Building Damage Report

Sample Property , Suburb withheld , NSW

21/10/2024

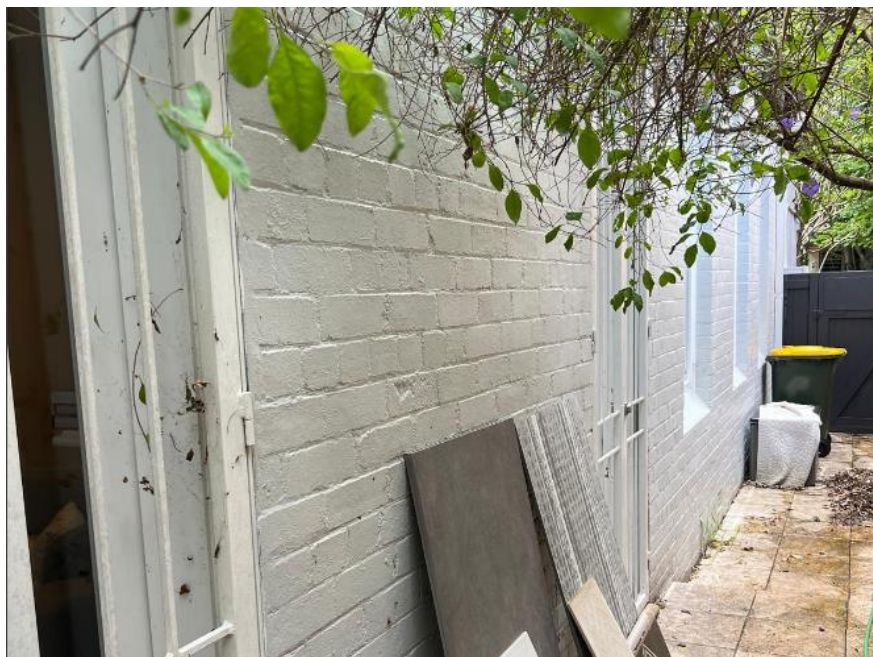
8. Complete replacement of all subfloor piers and structural elements that have been compromised, using materials and methods that meet current building standards. Refer to new engineer's detail.

No structural materials were noted as compromised. All inspected elements are in good condition.

The section of the subfloor timber not sitting on top of the brick is not structural but serves to reduce floor vibration (they are not bearers). The bricks are not structural brick piers (which should be a minimum of 230mm x 230mm) but are instead supports for non-structural horizontal timber.

The structural system supporting the floor consists of 120mm (H) x 50mm (W) joists at 450mm centers, made of hardwood timber. These joists are supported on either side by the building's foundation and external brick walls.

The timber sitting on the middle brick pier is 50mm (H) x 75mm (W), indicating that this section is NOT a bearer due to the following reasons:

- Bearers must be installed vertically with the larger dimension standing vertical to maximize load-bearing capacity.
- Bearers must sit on proper brick piers or posts; these are not structural brick posts.
- Bearer sizes should be larger than the joists (which is not the case) as they support more load compared to joists.

All the above evidence indicates that the loose timber is not structural and has no effect on the structural integrity. Its absence may cause increased floor vibration but does not compromise structural safety.

During the inspection, no cracks were found on the walls, further indicating satisfactory structural integrity.

No cracks noted to the
adjacent walls
